CITY OF ST. PETERSBURG, FLORIDA
PLANNING AND DEVELOPMENT SERVICES DEPARTMENT
URBAN PLANNING AND HISTORIC PRESERVATION DIVISION

STAFF REPORT

Community Planning and Preservation Commission
Certificate of Appropriateness Request

CITY FILE NO.: 19-90200064

Figure 4: Southeast storefronts, 1926. Location of proposed alterations outlined in blue by staff.
 Courtesy, Tampa-Hillsborough County Public Library System.

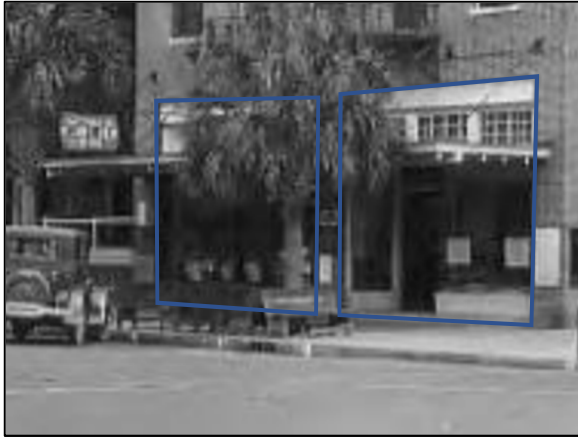
The existing conditions of the southwestern corner of the subject property, most recently the Detroit Liquors store, have been altered through the application of stucco over the brick exterior, the alteration of window and door openings, and the application of inappropriate faux-stone window surrounds (Figure 5). The division through the center of the façade seen below, as well as evidence observed inside and in historic photographs, suggests that the space historically housed two storefronts.

Since the two storefronts have been combined, one doorway has been eliminated. The sign board areas, which originally housed transom windows to provide light and air circulation, have been infilled, and a steel beam has been placed at the location of the header course. These historic elements of the storefront system are important to the building's design and feeling, and contribute significantly to the original sense of rhythm. An ideal historic rehabilitation would restore each individual element of the historic storefront shown in the ground floor of Figure 3. During pre-application meetings, staff recommended accomplishing this goal by reinstalling transom windows and, perhaps more importantly, by keeping a second but inoperable doorway present in the right storefront.

Figure 10: Proposed east elevation from application.

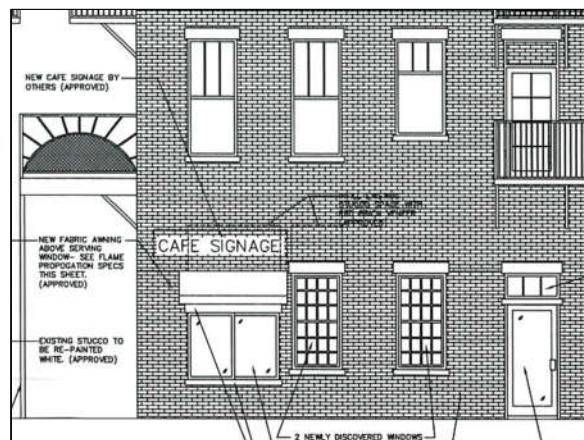
Given the discovery of these historic windows and openings, the applicant now proposes restoration of the historic wood sash windows, installation of a single-action door with transom lite in the historic door opening, and installation of a horizontal sliding window in the boarded “pass-through” at the southern edge of the east elevation (Figure 10).

Presumed consistent Window specs were not provided. Staff will confirm that proposed windows meet this criterion prior to final permit issuance. Staff recommends that the outline of each Central Avenue storefront (shown in Figure 6) be recessed to reference the historic configuration.

1. The applicant shall provide staff with confirmation of the proposed new windows' impact resistance, Energy Star rating, depth in wall plane, profile, and material/finish. New windows shall meet requirements for impact resistance and Energy Star rating for southern climates and shall be recessed within wall plane at a depth that closely matches the existing, historic windows at the east elevation.
2. New windows shall match the size of historic openings to the greatest extent possible, with the exception of the Central Avenue transom lights and the right Central Avenue-facing door, which may remain blind for structural and use purposes.
3. The storefront systems at the Central Avenue (south) façade will be referenced by a material distinction and recessed from their brick surrounds, as shown in the application.

APPROVED SOUTH ELEVATION

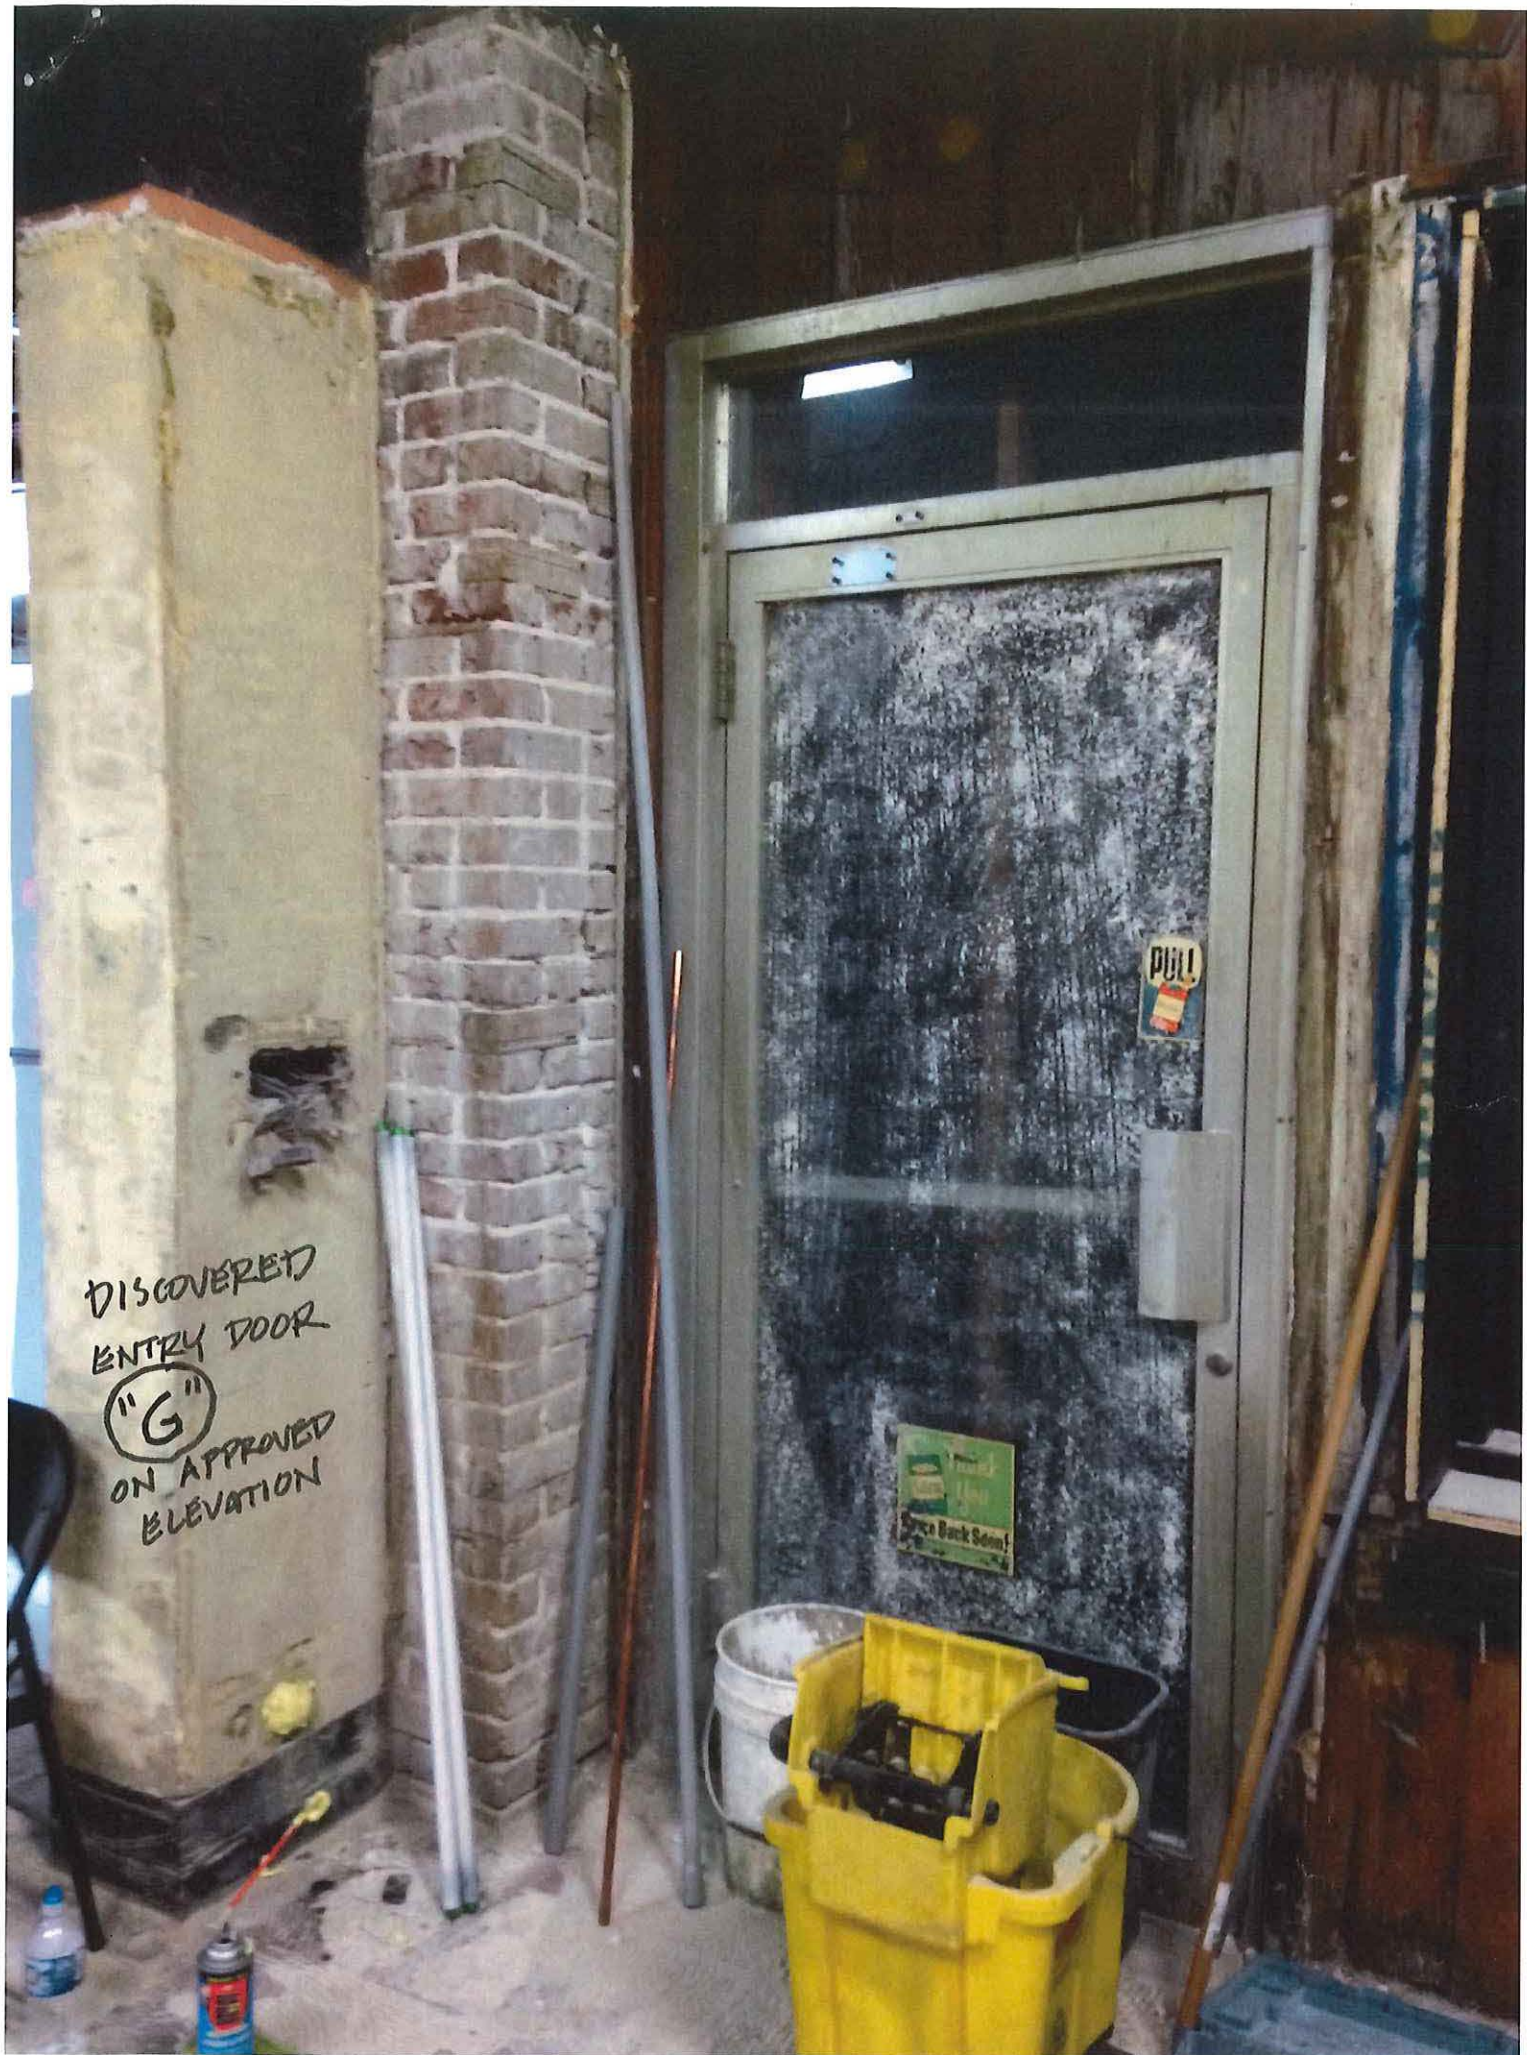
REQUEST ELIMINATING APPROVED TRANSOM FIXED GLASS
ABOVE WINDOWS ON CENTRAL AVENUE SINCE THERE IS NOT ADEQUATE
SPACE BECAUSE OF AN EXISTING STEEL BEAM & THE FACT THAT THE
2 EXISTING WINDOWS ARE TALLER THAN WAS INDICATED ON THE
APPROVED ELEVATIONS.

- A** THERE ARE NO FALSE WINDOWS TO RESTORE. THIS AREA IS FRAMED-IN AND COVERED WITH A STUCCO PANEL AFTER DEMOLITION OF INTERIOR.
- B** THERE IS A 14 INCH TALL STEEL BEAM PAINTED DARK GREEN TO MATCH EXISTING BALCONY METAL (SEE EXISTING ELEVATION). THIS LEAVES VERY LIMITED SPACE TO INSTALL ANY NEW TRANSOM WINDOWS BELOW THIS BEAM AND ABOVE THE EXISTING WINDOWS.

- C** THERE IS NO EXISTING BRICK IN THIS AREA TO RESTORE EXCEPT POSSIBLY THE 24 INCH WIDE COLUMN WHICH WE WOULD INTEND TO DO. HOWEVER WE COULD APPLY NEW BRICK PAVERS TO THIS AREA AS PREVIOUSLY SUGGESTED.

- D** THESE 2 EXISTING VENTED AREAS ARE ONLY 12 INCHES TALL AND NOT 30 INCHES AS INDICATED.
- E** WE HAVE UNCOVERED 2 ORIGINAL WINDOWS AND WHEN REMOVING THE STUCCO PANELS FROM THE SIDE OF THE BUILDING, RESTORE THESE WINDOWS TO THEIR ORIGINAL CONDITION.

- F** WE HAVE UNCOVERED THE ORIGINAL SIDE DOORWAY WHICH WE THINK HAS BEEN CLOSED SINCE THE 1930'S AND WILL BE INSTALLING A NEW PERIOD APPROPRIATE DOOR WHICH WILL BE SUBMITTED PRIOR TO INSTALLATION FOR APPROVAL.

- G** WE DISCOVERED THERE IS NO BRICK IN THIS AREA TO BE RESTORED AND THERE IS AN ORIGINAL FRONT ENTRY DOOR.

EXISTING EAST ELEVATION

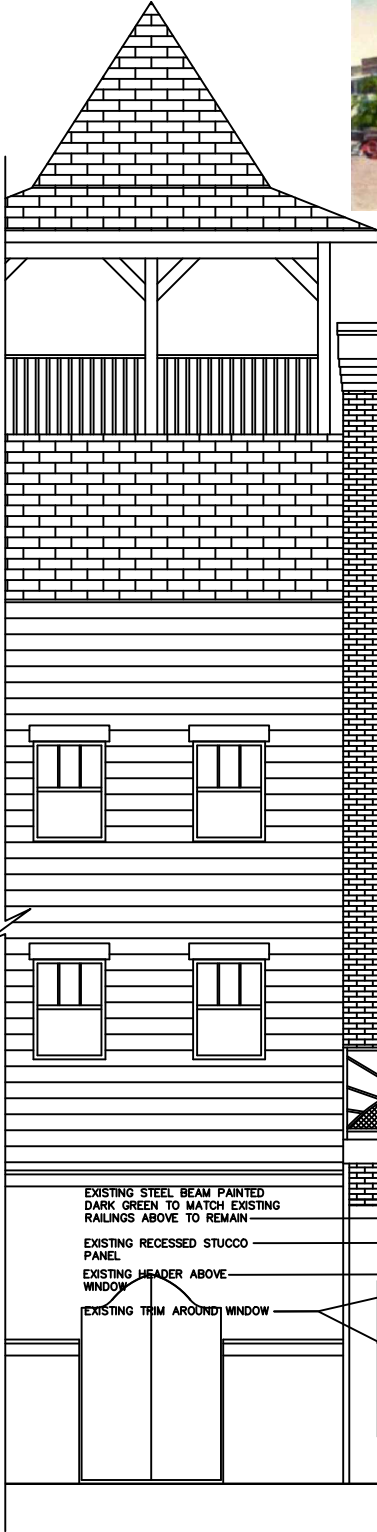
1. VERIFY WINDOW OPENING DIMENSIONS
